Subject: Duke Energy Carolinas, LLC
Oconee Nuclear Station
Renewed Facility Operating Licenses Numbers DPR-38, DPR-47, and DPR-55;
Docket Numbers 50-269, 50-270, and 50-287
Responses to Request for Additional Information for the License Amendment
Request to Revise Portions of the Updated Final Safety Analysis Report Related to
the Tornado Licensing Basis; License Amendment Request: 2006-009

Duke Responses to RAI

- NEW CABLE TRAY HANGER
- ELECTRICAL LIGHTING FIXTURE (TO BE RELOCATED)
- AC EMERGENCY LIGHTING FIXTURE (TO BE RELOCATED)
- X HVAC VENT (TO BE RELOCATED)

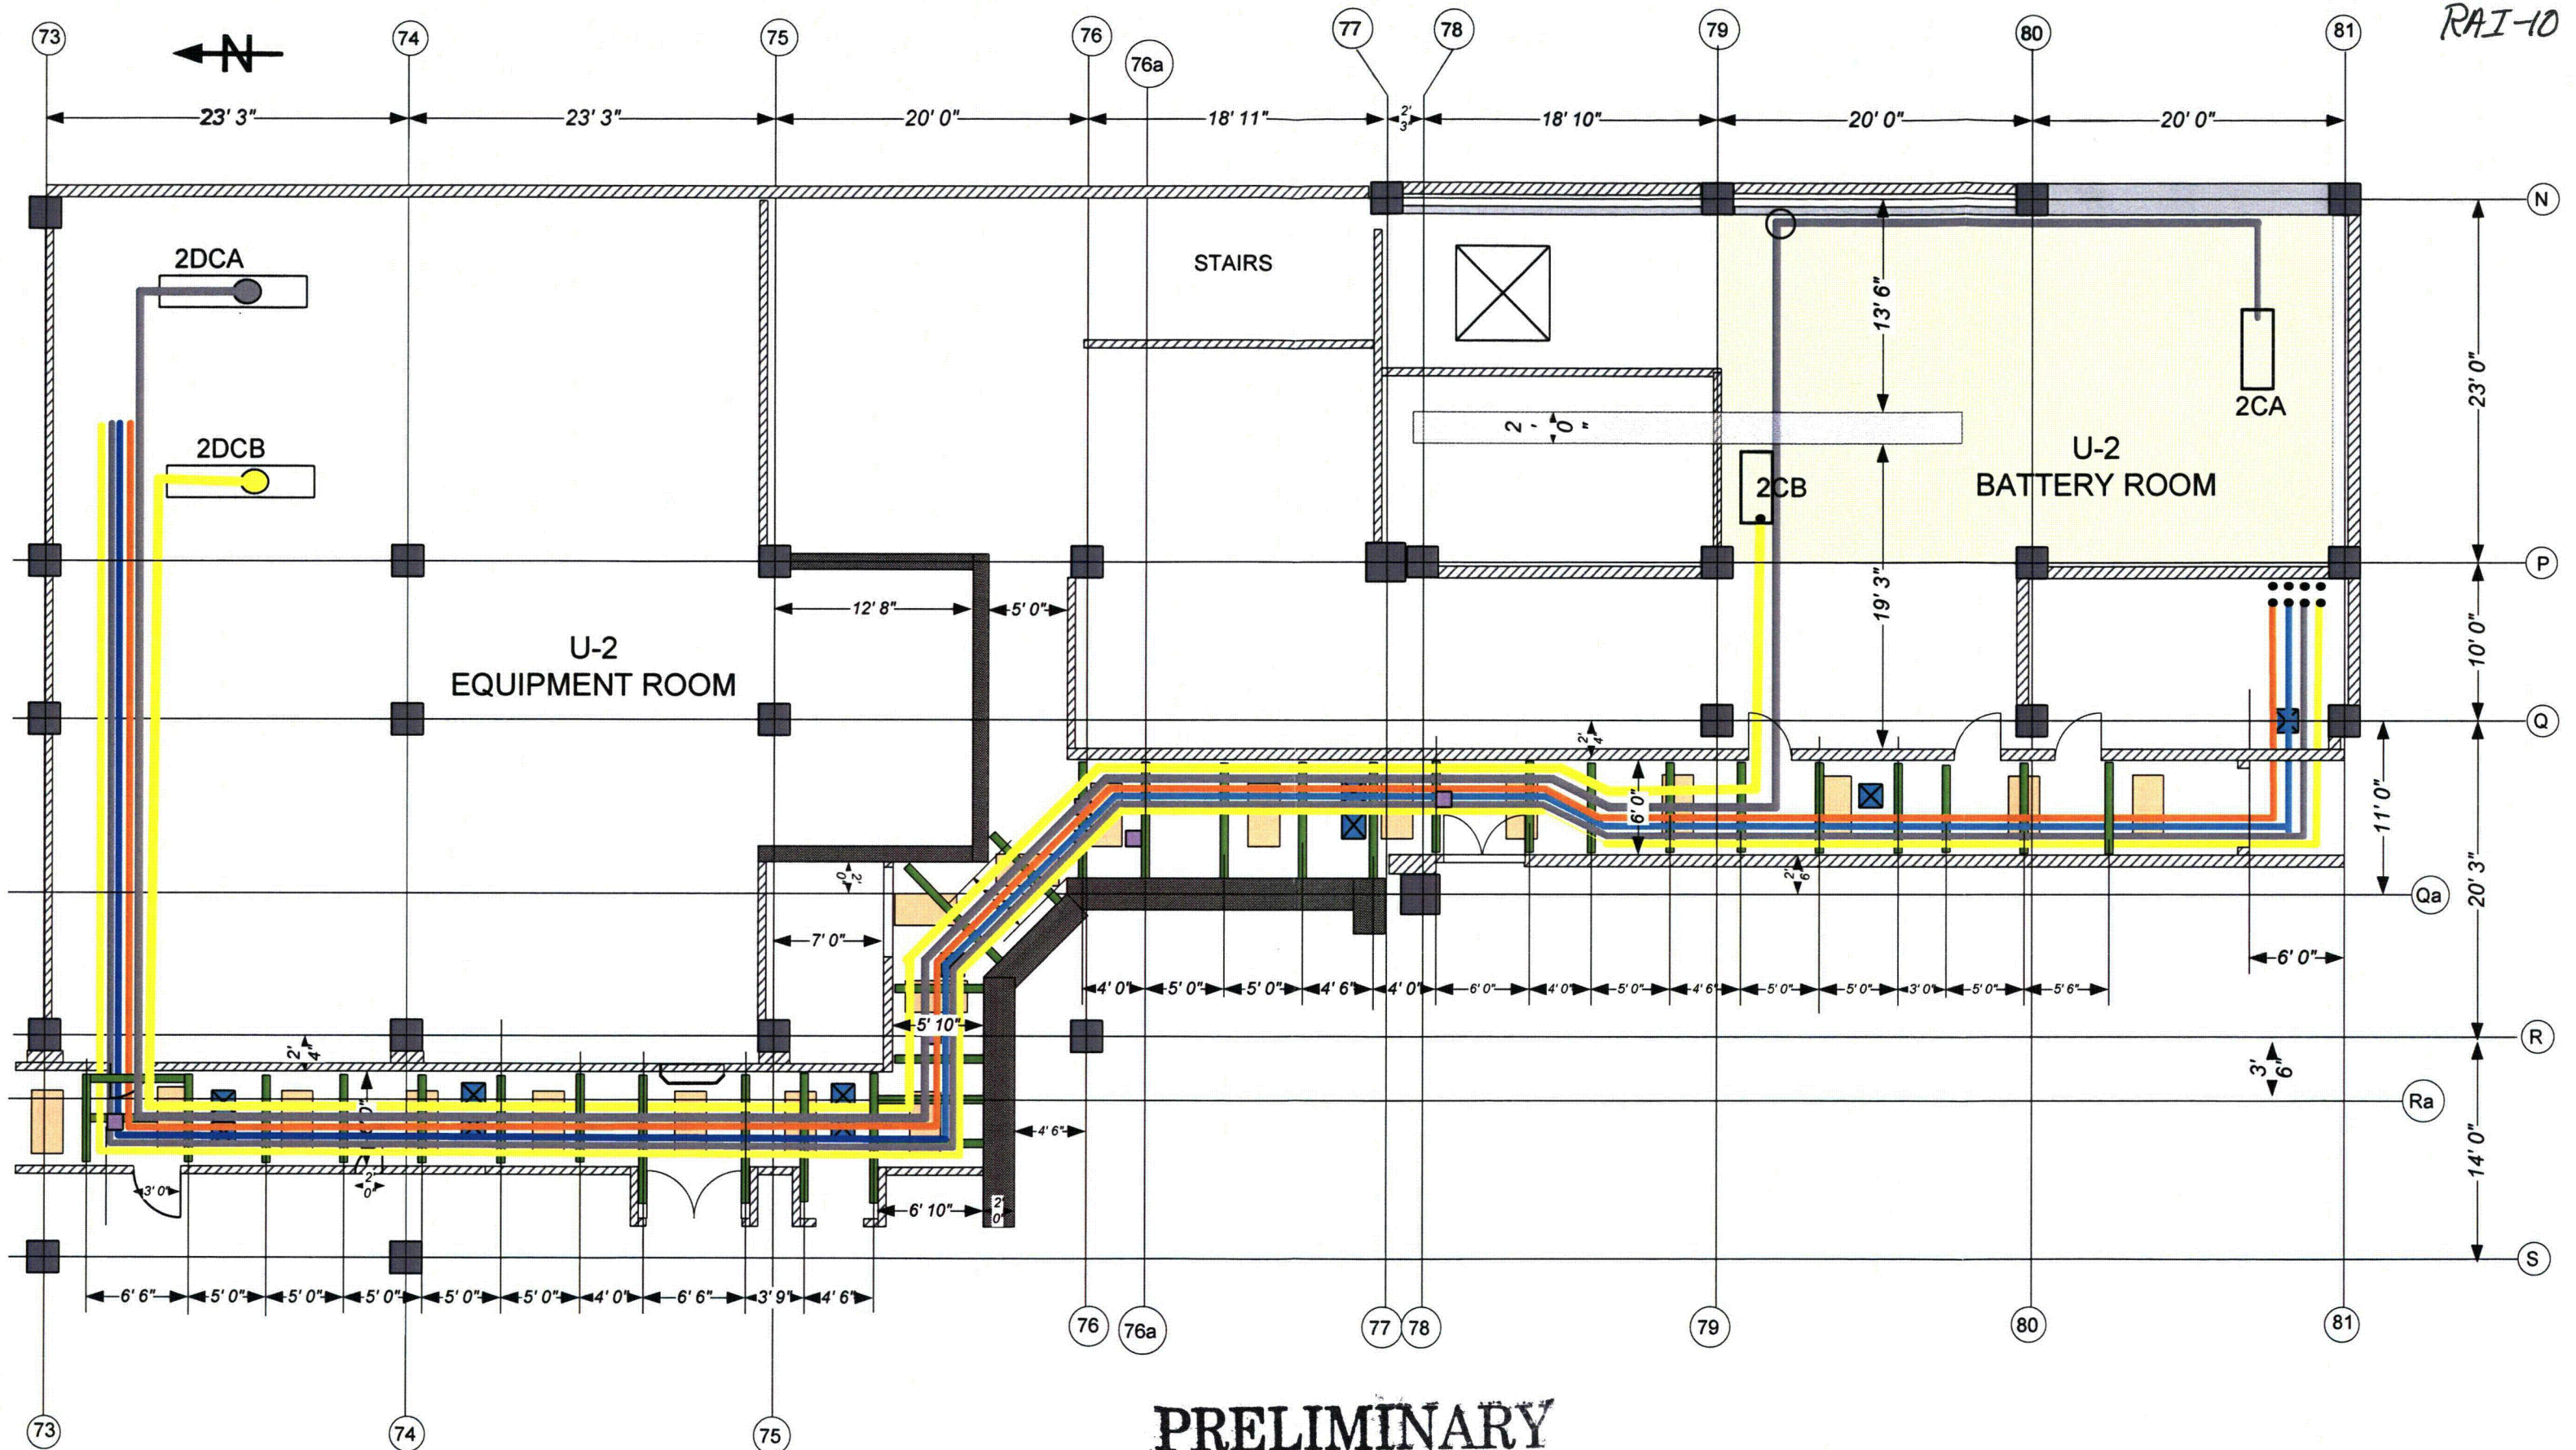
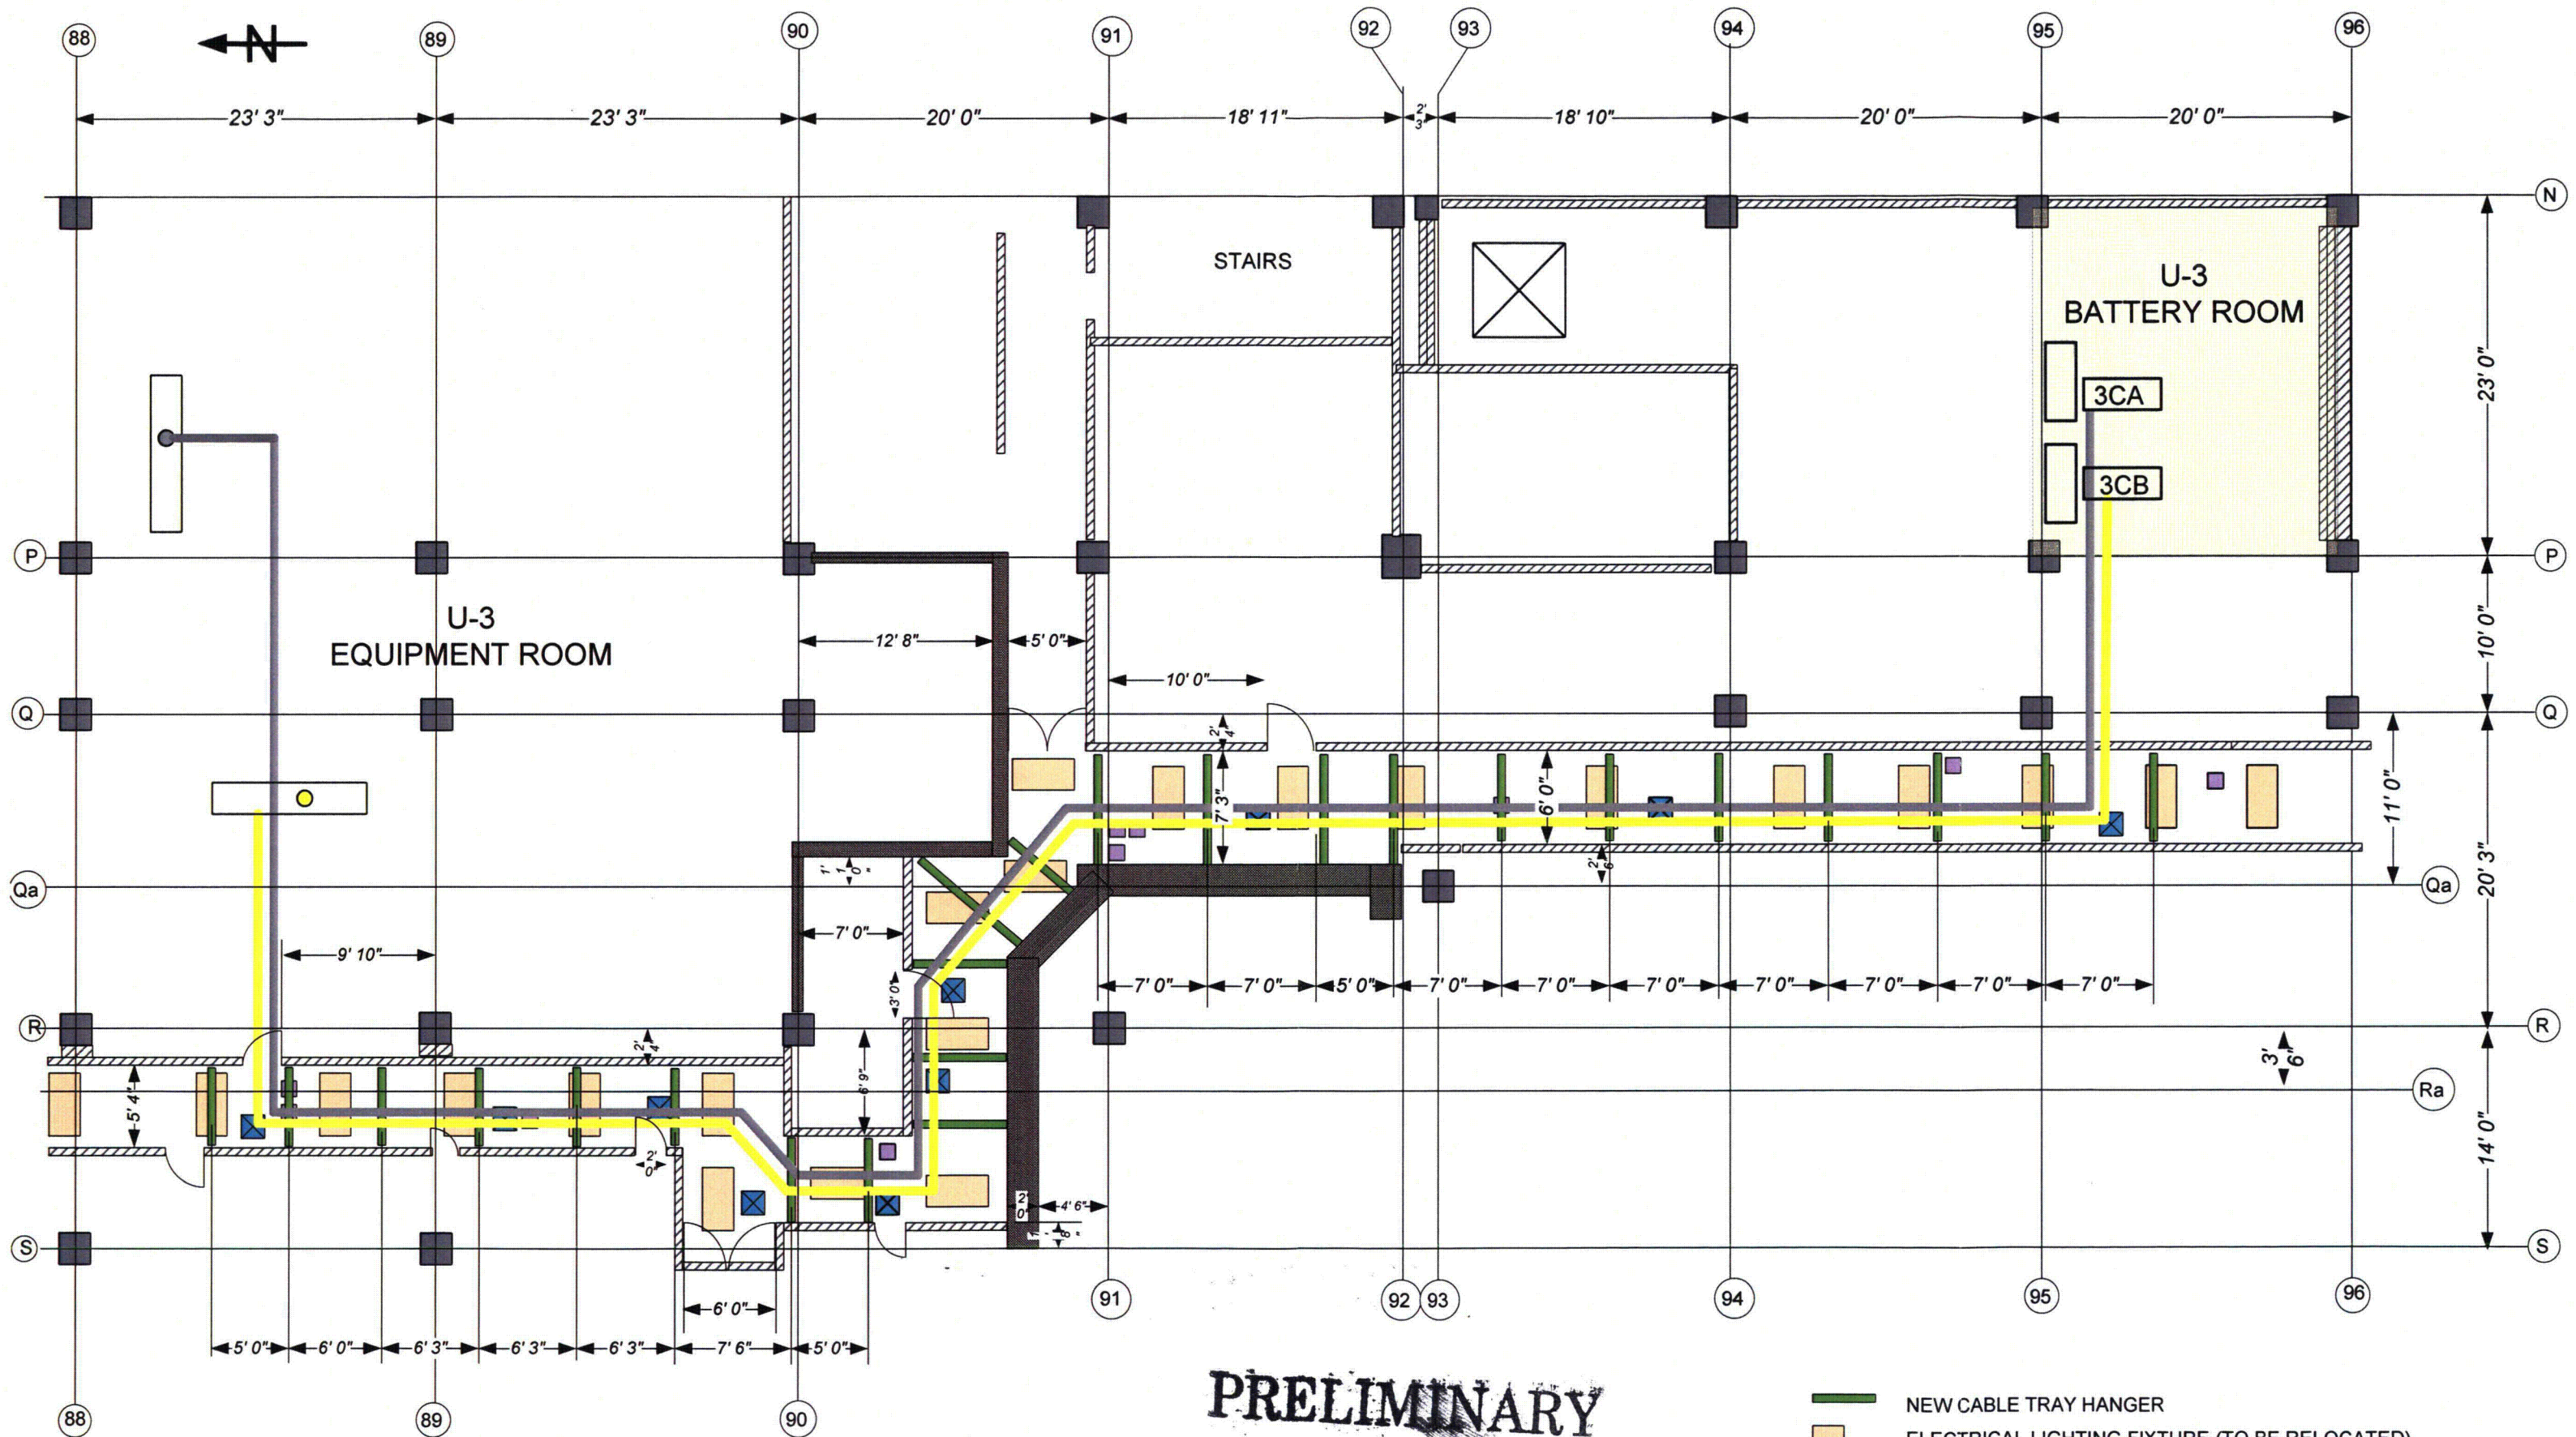
Describe in detail how the 125 VDC vital I&C primary and backup power cables and the KHU emergency start circuitry will be rerouted from the turbine building (TB) to the AB.

design basis events. The new cable routing will not affect the system functional characteristics and the termination points and each end of the cables will not change.

This design change provides new routing for the Keowee Hydro Units (KHU) emergency start cables. The existing underground spare cables between KHU and the Oconee Station will be used. For tie-in to control and logic, these underground cables will be extended with new cables between KHU termination cabinets to KHU control panels and Oconee termination cabinets to control panels in the Auxiliary Building. New emergency start cables will be installed from the 230 kV switchyard relay house via a new protected underground duct bank to the PSW switchgear building and, underground via protected duct bank, to the Auxiliary Building control panels.
